Contamination management strategy for East Perth Gasworks site and adjacent areas of the Swan River

State Energy Commission of Western Australia (SECWA)

**Report and recommendations
of the Environmental Protection Authority**

**Environmental Protection Authority
Perth, Western Australia
Bulletin 651
October, 1992**

PLAN OF EAST PERTH AREA

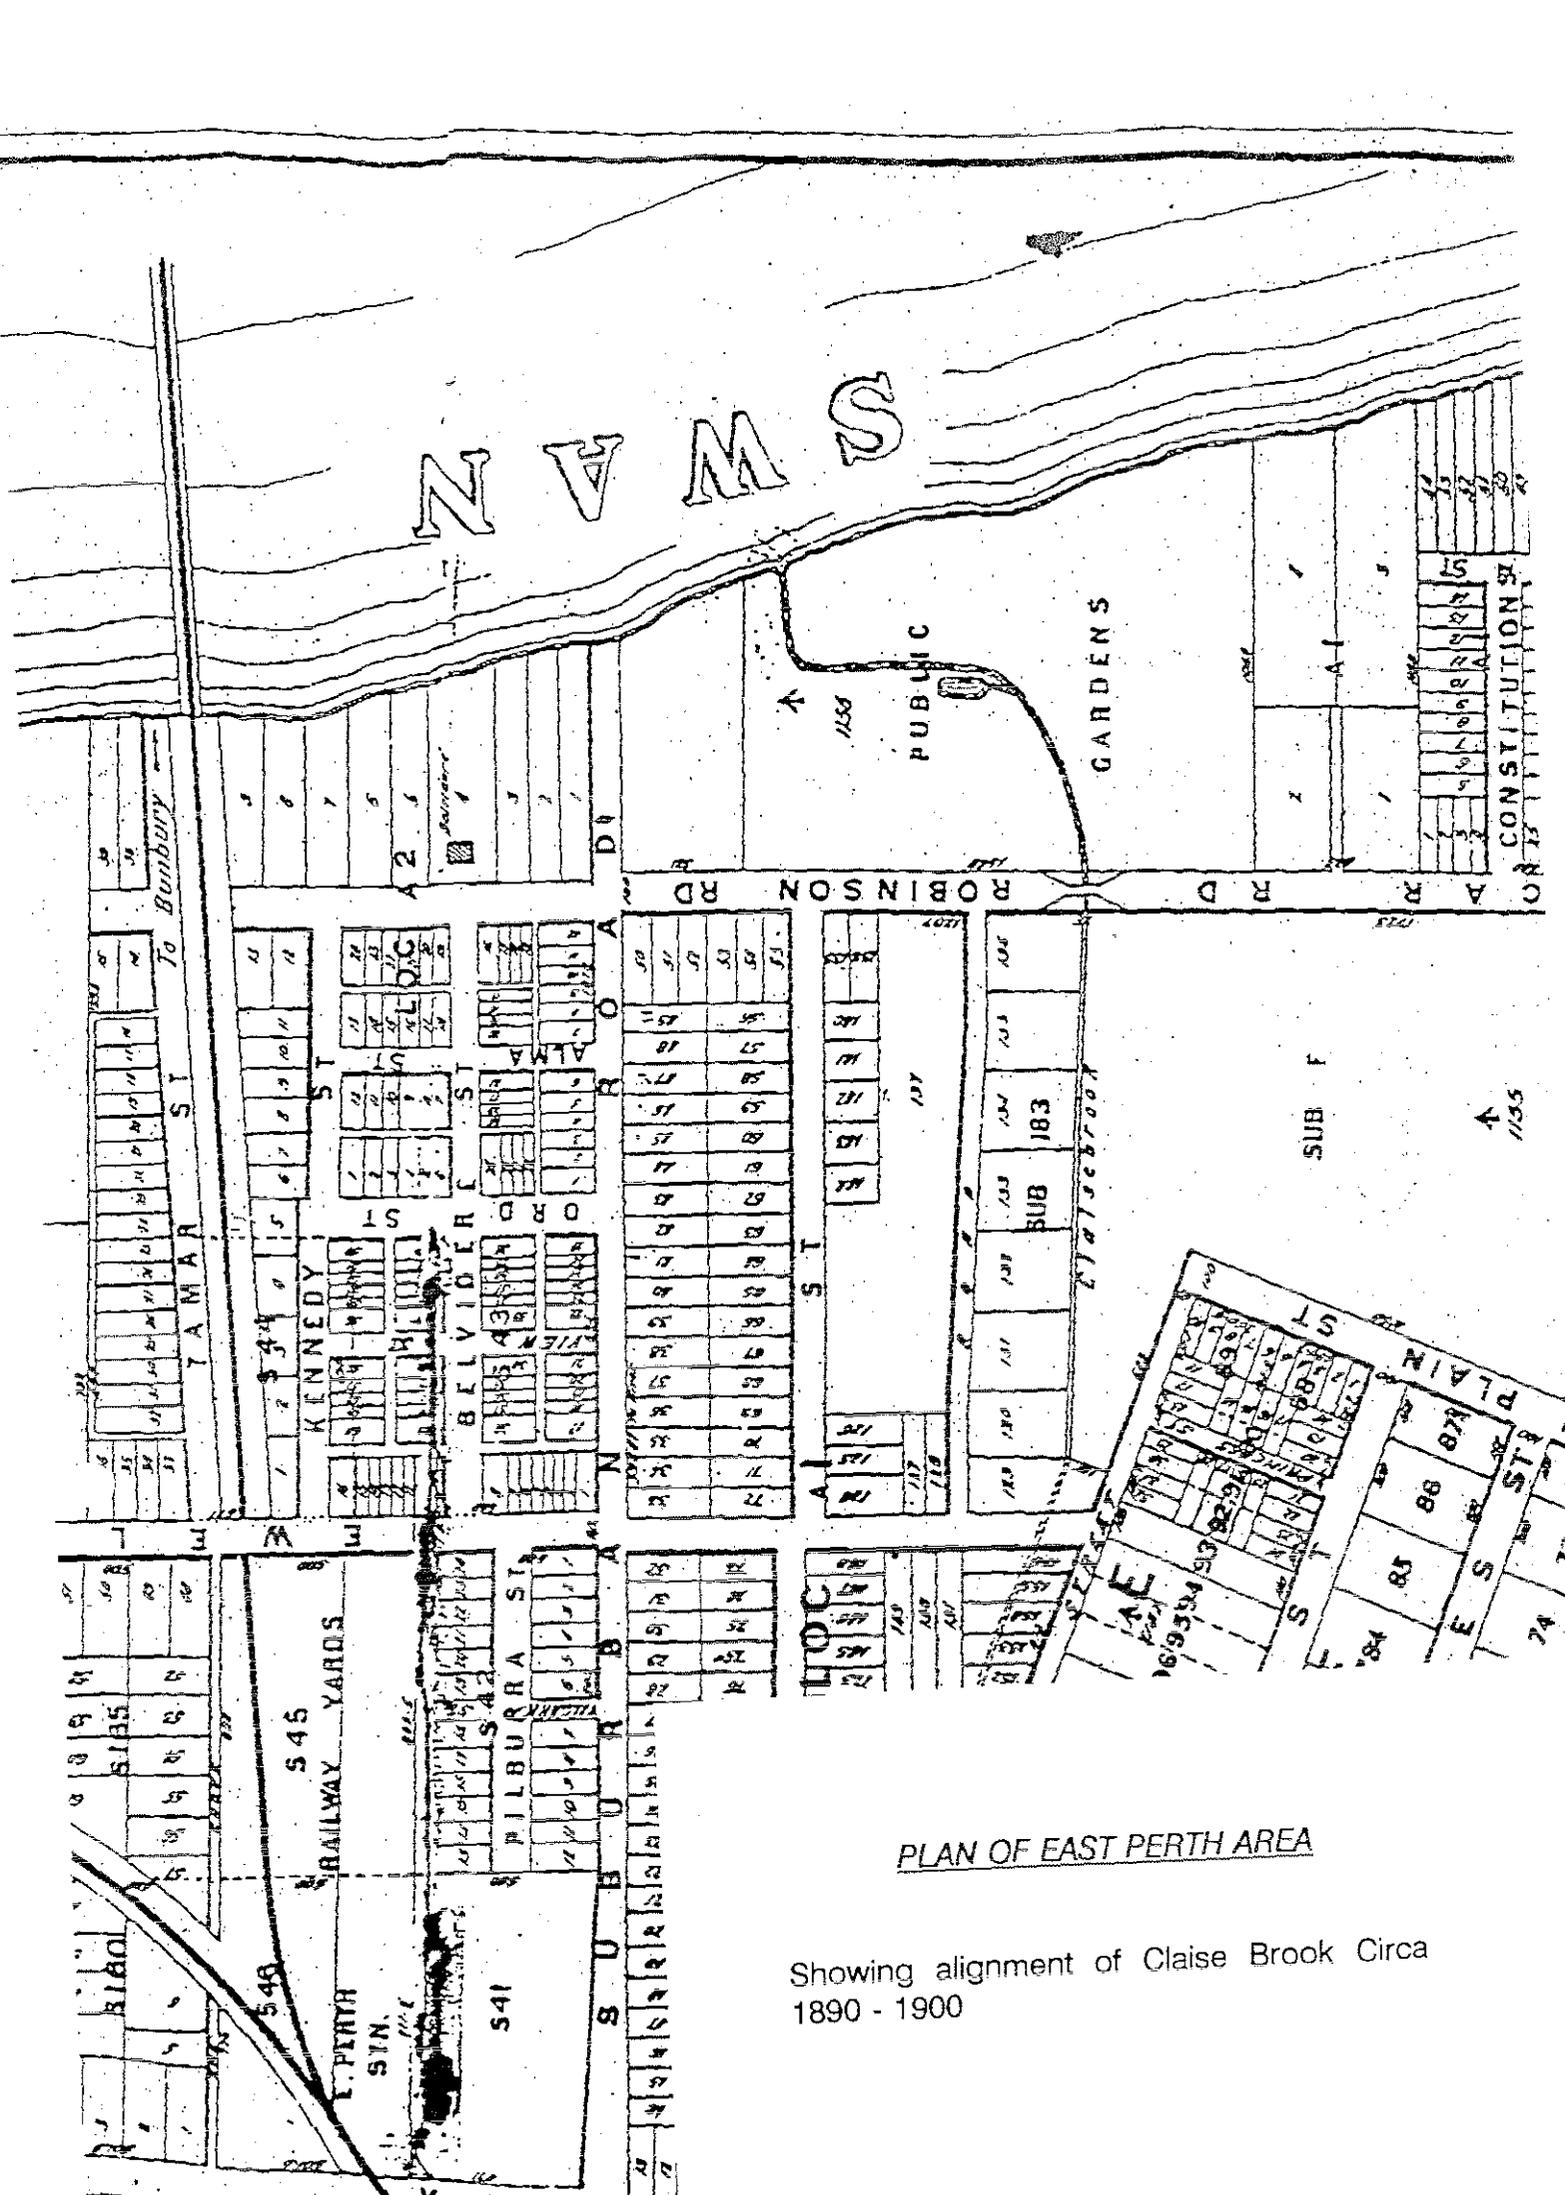
Question 1.11

Historical records are not definite about the original course of Claise Brook. It is known that the Brook was first straightened and canalised (by boarding) in 1920. Best estimates suggest the original alignment was as depicted in the enclosed plan. The date of the plan is not known but is thought to be about 1890 or 1900. Most of the site was originally a river depositional area, progressively reclaimed over the years. This is evident from the borehole stratigraphy.
